# Access Compliance Report

## Public Rights-of-Way

### (Curb Ramps)

| Intersection ID: 50511                  | Main Street: ALLEN_A_BROWN_RD | Cross Street: MERIDALE_CROSSING_DR      | Location:              | N                  |

| ADA ID: 8FC9CE5256EB                    | Ramp Type: PerpDiag           | Initial Pass/Fail: Fail                 | Overall Compliance: No | Severity Score: 10 |

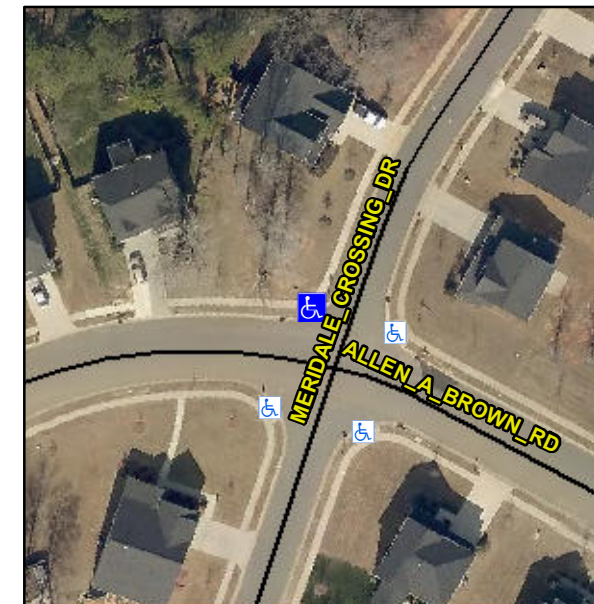
**Remove & Replace Curb Ramp With Two New Directional Ramps or Equivalent.**

**R304.5.1, R304.5.3**

| Compliance | Description           | Data  | Compliance | Description                 | Data  |
|------------|-----------------------|-------|------------|-----------------------------|-------|
| N/A        | Ramp Length (in)      | 47.5  | Yes        | Ramp Slope (%)              | 7.8   |
| No         | Ramp Width (in)       | 47.0  | No         | Ramp XSlope (%)             | 3.8   |
